NFPA 13
PERMIT

Unified Fire Authority
Fire Prevention Division

Date: February 5, 2021

Project: La Caille

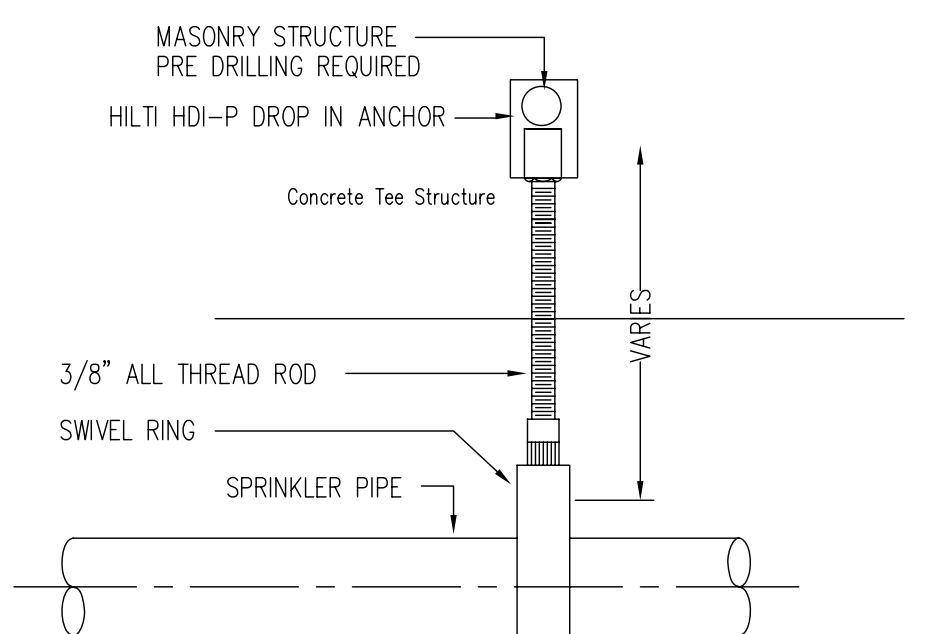
- Verify that there are no obstructions to fire sprinkler spray pattern development.
